DART+ West Project  
Section A: Spencer Dock to M50

Stage 1 Road Safety Audit

<b>Document Ref:</b>	<b>P22-021-PSW1-RP-001</b>
----------------------	----------------------------

*Drawing:* MAY-MDC-HRW-SC01-DR-Z-0001-C (V02)

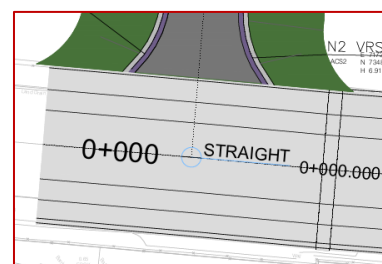
*Summary:* Working width for the VRS/Safety Barrier

A Vehicle Restraint System (VRS) has been indicated on either side of the proposed compound access on the immediate approach to its junction with Sheriff Street.

A verge width of 0.5m has also been indicated on the Access, and it is unclear if this verge is of sufficient width to accommodate the proposed VRS with the required setback & working width.

A lack of sufficient Working Width for the safety barrier may result in the barrier not performing as expected when struck resulting in an increased injury severity outcome for occupants of an errant vehicle.

Level ground should be provided within the extents of the working width of the proposed VRS/safety barrier and the working Width should be kept free of items of roadside furniture (e.g. sign supports, public lighting columns).

*Drawing: MAY-MDC-ARC-RS02-DR-A-0006-C (V01)*

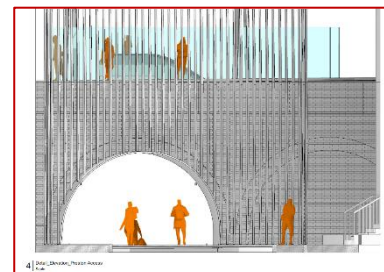
*Summary: No 'Safe Zone' indicated along Preston Street.*

It is proposed to provide new pedestrian access route to Conolly Station via Preston Street. It is unclear if vertical separation is proposed within the revised street layout, implying the provision of a "Shared Street" arrangement.

However no "Safe Zone" has been indicated, the absence of which could create difficulties for visually-impaired pedestrians in safely & independently navigating the proposed street layout.

A "Safe Zone" should be provided in line with guidance by the National Disability Authority. The Safe Zone should extend up to/into the station entrance and connect with the footpath along Amiens Street.

*Drawing: MAY-MDC-LAN-RS02-DR-A-0001-C (V01)*

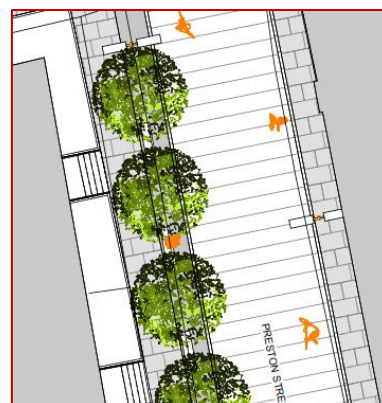
*Summary: Lighting column(s) position may reduce the effective width of the "footpath" along the eastern side of Preston Street.*

It is proposed to provide lighting columns close to the interface between the eastern footpath and the shared-area/carriageway. The position of these lighting columns could reduce the effective width of the "footpath" area presenting an obstacle to the mobility-impaired or a hazard to the visually-impaired.

The lighting columns should be positioned to the rear of the footpath, or if possible lighting columns provided only within the "buffer area" along the western side of the street.

*Drawing: MAY-MDC-ARC-RS02-DR-A-0006-C (V01)*

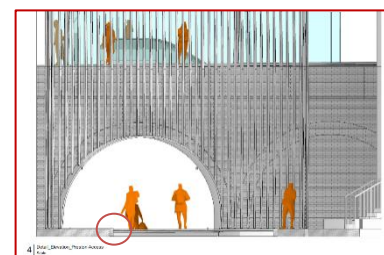
*Summary: Upstand within pedestrian area may present a trip hazard.*

Elevation 4 appears to indicate a small level difference between the shared surface/carriageway area and the adjacent footpaths. It is unclear what the height of this level difference is intended to be. Should the proposed level difference be too small it may present a trip hazard for inattentive pedestrians or the partially-sighted.

Care should be taken to ensure that the level difference does not present a potential trip hazard, and that the footway area extends into the station entrance.

Drawing: MAY-MDC-ARC-RS02-DR-A-0006-C (V01)

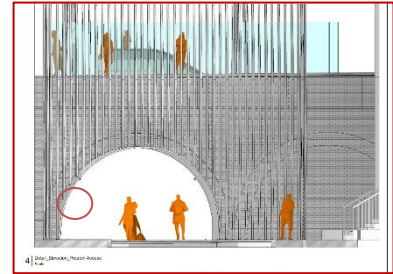
Summary: Height hazard at the arched entrance to the station.

Elevation 4 indicates that there will be a footpath on either side of the arch at the entrance to the station. There is a concern that due to the low height of the arch on both sides, visually-impaired pedestrians might not be aware of the height hazard and may result in personal injury if struck.

Measures should be provided to ensure that pedestrians are guided away from the arch sections with height lower than 2.1m.

Drawing: MAY-MDC-STR-RS05-DR-C-0002-C (V04)

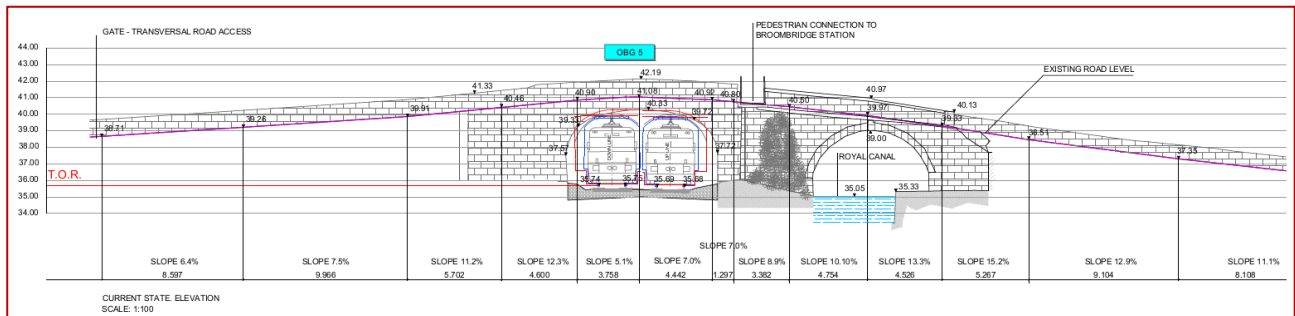
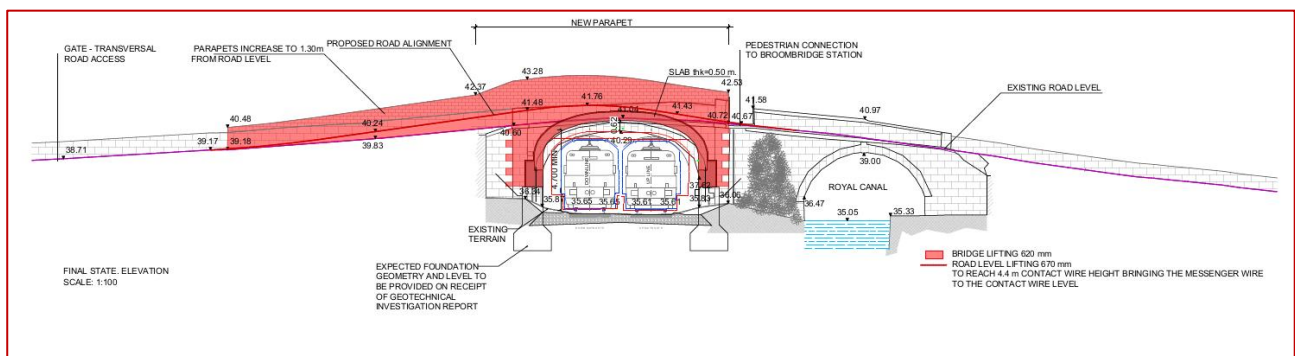
Summary: Proposed changes to the vertical alignment may create difficulties during wet/icy weather or lead to vehicle "grounding" at the crest.

No details have been provided in relation to the proposed vertical alignment of Broombridge Road. It would appear that it is proposed to increase the gradient and, possibly, reduce the k-value of the crest curve in the vicinity of the railway crossing.

A reduced crest curve k-value could lead to reduced forward visibility for drivers on Broombridge Road towards the pedestrian and cyclist crossing on the northern side of the bridge resulting in possible overshoot collisions. A reduced crest k-value could also result in large vehicles (e.g. buses) 'grounding' on the crest.

Increased gradients could increase the difficulties, in particular for elderly or mobility-impaired pedestrians, travelling along Broombridge Road, or for all pedestrians during wet or icy weather resulting in slips or falls. The increased gradient could also give rise to difficulties for vehicles in ascending the gradient during icy weather, in particular for the north-facing section of the road.

The vertical alignment, and in particular the gradients, should be such so as not to create hazards for vehicles or non-motorised road users in particular during wet/icy weather.

The crest curve k-value should be such that it does not reduce a northbound driver's forward visibility towards the existing toucan crossing at the Greenway and is capable of being safely traversed by all vehicles permitted or likely to use the road.

*Drawing: MAY-MDC-ARC-RS07-DR-A-0003-C (V03)*

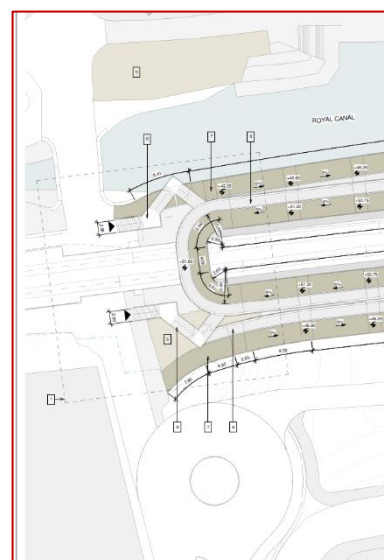
*Summary: No clearly defined route between the proposed bridge and adjacent pedestrian/cyclist facilities.*

It is unclear what treatment is proposed to the existing carriageway on the canal overbridge (between the new mini-roundabout to the north and the access to the stairs/ramp/platform), although it is presumed that this will be a shared pedestrian/cyclist surfaces. No clearly defined route has been indicated connecting the new overbridge ramps/steps to the footpaths in the vicinity of the mini-roundabout, including dropped kerbs & tactile paving. It is therefore unclear what route mobility-impaired non-motorised road users should take to/from the northern steps/ramp.

Similarly, it is unclear how cyclists are intended to transition from the carriageway to the new shared surface.

An absence of appropriate provisions could result in difficulties for the mobility-impaired travelling to/from the new facility from the existing roads to the north of the canal.

Measures to cater for cyclist and pedestrian access to the new overbridge to/from the area north of the canal should be incorporated during the design development.

*Drawing: MAY-MDC-ARC-RS07-DR-A-0004-C (V02)*

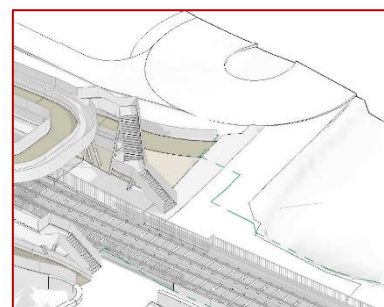
*Summary: Unclear if sufficient inter-visibility will be available between cyclists and pedestrians at the bottom of the ramp on the southern side of the railway.*

A fence is indicated along the outside edge of the ramp on the southern side of the new overbridge. It is unclear what type of fence is proposed, and whether it will afford inter-visibility between cyclists descending the ramp and pedestrians approaching from the eastern side of the turning head.

The proposed layout will result in pedestrians approaching the ramp, wishing to pass in front of it to access the station or the steps/ramp, not being visible to a descending cyclist and vice versa, resulting in possible cyclist/pedestrian collisions.

The layout at the foot of the ramp should be such that it minimises, or removes, the need for pedestrians travelling to the station or steps to have to cross the path of cyclists travelling to/from the ramp. Where this is not feasible/practicable, then the layout should ensure adequate inter-visibility between all users approaching the bottom of the ramp and sufficient space provided to accommodate the expected volumes of pedestrians/cyclists at this location.

In addition, a clear route to/from the ramp & the “carriageway” for cyclists should be provided.

*Drawing: MAY-MDC-HRW-LC01-DR-C-0101-C (V01)*

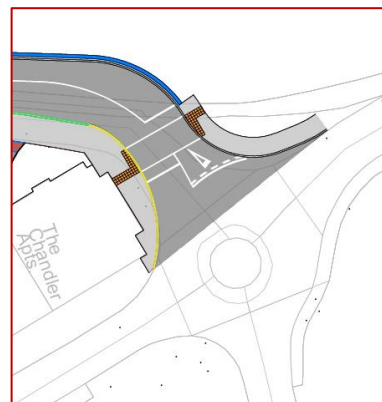
*Summary: Proximity of car-park access to the mini-roundabout may give a rise to conflicting manoeuvres.*

The proposed mini-roundabout at the Mill Lane junction with the Ashtown Road is in close proximity to the entrance to the Ashtown Gate carpark. In addition, a signalised crossing is indicated immediately south of the mini-roundabout.

The proximity of the car park access and the signalised crossing to the roundabout could result in complicated combinations of turning manoeuvres leading to driver uncertainty regarding the intentions of other drivers when indicating to turn resulting in possible shunts.

The proposed junction layout should be reconsidered, and it may be that a signalised junction would better accommodate the expected turning manoeuvres & volumes, and the proximity of the Ashtown Gate carpark access within it.

*Drawing: MAY-MDC-HRW-LC01-DR-C-0103-C (V01)*

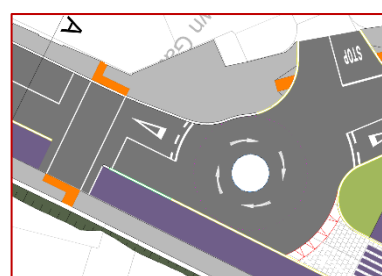
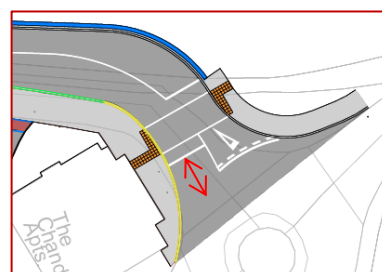
*Summary: Proximity of crossing to the roundabout might increase the risk of overshoot collision*

It is proposed to provide a signalised crossing across the western arm of the Ashtown Road/Rathborne Avenue roundabout and across the southern arm of the Ashtown Road/Mill Lane mini roundabout.

The proximity of the proposed signalised crossings to the roundabouts may be too close for exiting drivers to recognise the status of the signals in enough time to come to a halt, resulting in a risk of overshoot collisions.

Signalised crossings should be located a sufficient distance from the roundabout's to allow drivers exiting from the roundabouts adequate distance/time to come to a halt.

*Drawing:* MAY-MDC-HRW-LC01-DR-C-0102-C (V01)

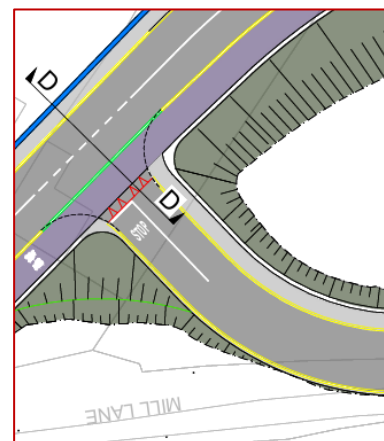
*Summary:* Lack of connectivity between the footpath on Mill Lane Access Link and the footpaths on the realigned Mill Lane.

It is proposed to provide a footpath along the Mill Lane Access Link, however no connection has been indicated to the footpath on the realigned Mill Lane, presenting difficulties for the mobility-impaired in safely and independently navigating the proposed road layout.

A crossing should be provided between the footpath on the realigned Mill Lane and the Mill Lane Access Link.

Drawing: MAY-MDC-HRW-LC01-DR-C-0103-C (V01)

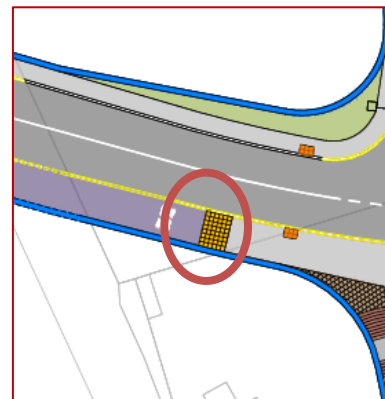
Summary: Unclear if Tramline Tactile Paving is proposed at the commencement of the two-way cycle track.

Tactile paving has been indicated at the commencement of the two-way cycle track, however, it is unclear from the drawing if 'Tramline' tactile paving is proposed at this location. The absence of the appropriate tactile paving at this location may result in visually-impaired pedestrians not being aware that they are entering a section of path dedicated to cyclist use, increasing the risk of conflicts with cyclists.

Tramline tactile paving should be provided at the interface of the two-way cycle track and the footpath.

Drawing: MAY-MDC-HRW-LC01-DR-C-0103-C (V01)

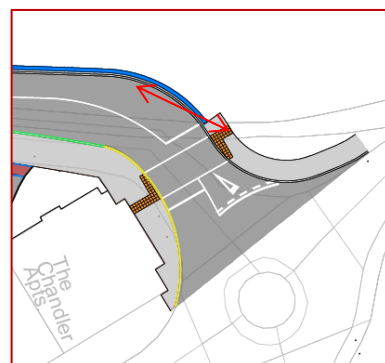
Summary: Inter-visibility between pedestrians at the controlled crossing and approaching drivers may be impeded by the adjacent boundary/retaining wall.

A controlled crossing is proposed across the western arm of the Ashtown Road/Rathborne Avenue roundabout.

The boundary/retaining wall to the west of the northern crossing point may impede inter-visibility between a pedestrian about to commence a crossing and an approaching driver resulting in a failure to stop and possible vehicular/pedestrian collisions.

Adequate inter-visibility should be provided between pedestrians at the crossing and approaching drivers.

*Drawing: MAY-MDC-HRW-LC01-DR-C-0104-C (V01)*

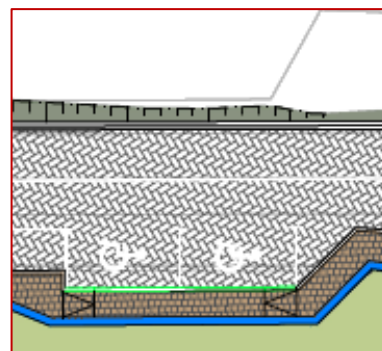
*Summary: No tactile paving provided at the dropped kerb at proposed mobility-impaired parking spaces.*

Mobility impaired parking spaces have been indicated on Ashtown Road, to the south of the canal/railway. A dropped kerb has been indicated between the footpath and the parking spaces, however, no tactile paving has been indicated at this dropped kerb.

The absence of tactile paving at the dropped kerb location could result in a visually-impaired pedestrian inadvertently entering the carriageway where there is an increased risk of collisions with vehicles or cyclists.

At locations where mobility impaired parking spaces are provided at a different level to the adjacent footpath tactile paving should be provided at the dropped kerb as recommended in 'Building for Everyone: External Environment and Approach,' published by the National Disability Authority (NDA).

*Drawing: MAY-MDC-HRW-LC01-DR-C-0104-C (V01)*

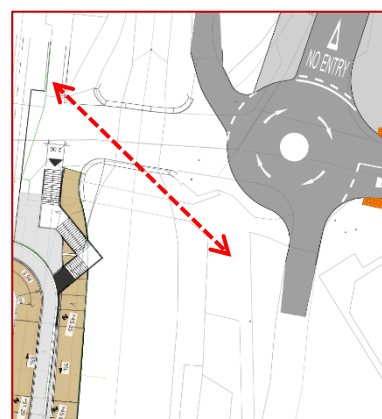
*Summary: Unclear if route will be provided for cyclists between the northern & southern sides of the Greenaway.*

It is unclear what treatment is proposed to the existing carriageway on the canal overbridge (between the new mini-roundabout to the north and the access to the stairs/ramp/platform).

The Royal Canal Greenway switches sides at this location from south of the canal to north of the canal. A lack of clear provisions along the likely cyclist route might increase the risk of conflicts between pedestrians & cyclists.

A clear route for cyclists travelling along the Greenway to the south and north of the canal should be provided.

*Drawing: MAY-MDC-STR-LC01-DR-C-0010-C (V03)*

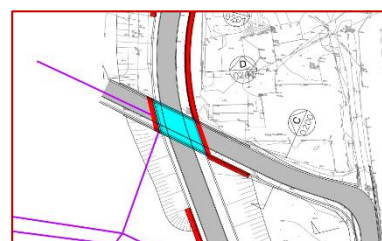
*Summary: Unclear what vertical clearance is proposed at the Mill Lane Link overbridge.*

It is proposed to provide an overpass for the Mill Lane Link, however no information is provided on the proposed vertical clearance under this overbridge. Should insufficient clearance be provided this could result in material damage collisions for high vehicles traveling along the realigned Mill Lane.

Adequate vertical clearance should be provided at this location.

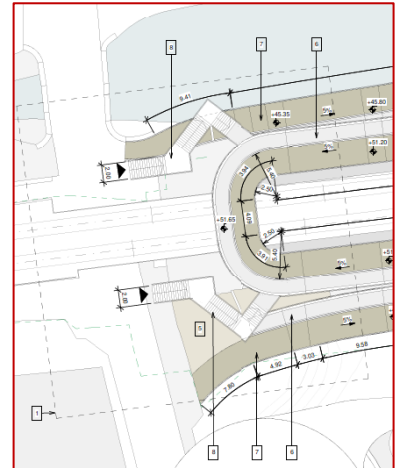
- 4.1.1 There may be insufficient landings on the proposed steps either side of the railway. The National Disability Authority guidance is that there should be a landing for every 1.5m in rise.

The total level difference appears to be c. 6.5m, which would require 3 intermediate landings. The landings should be equal in depth to the width of the stairs.

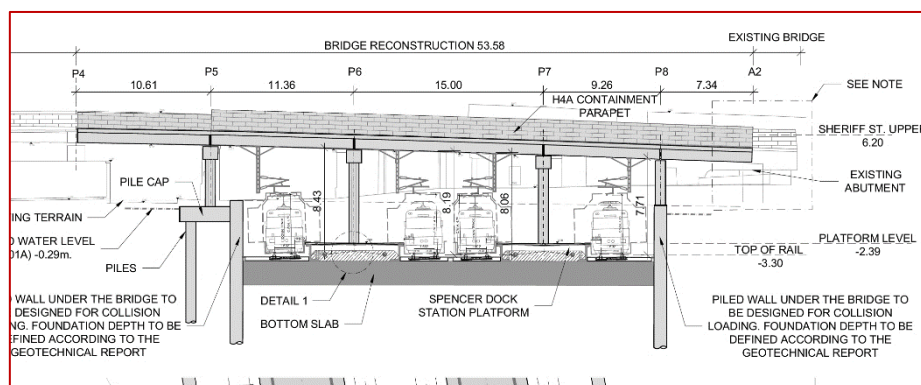
- 4.3.1 It is proposed to remove a section of Sheriff Street Bridge and reinstate it. It would appear from the drawings provided that no vertical changes are proposed. Care should be taken during the reinstatement of the carriageway that the road's longitudinal profile is smooth and curvilinear.
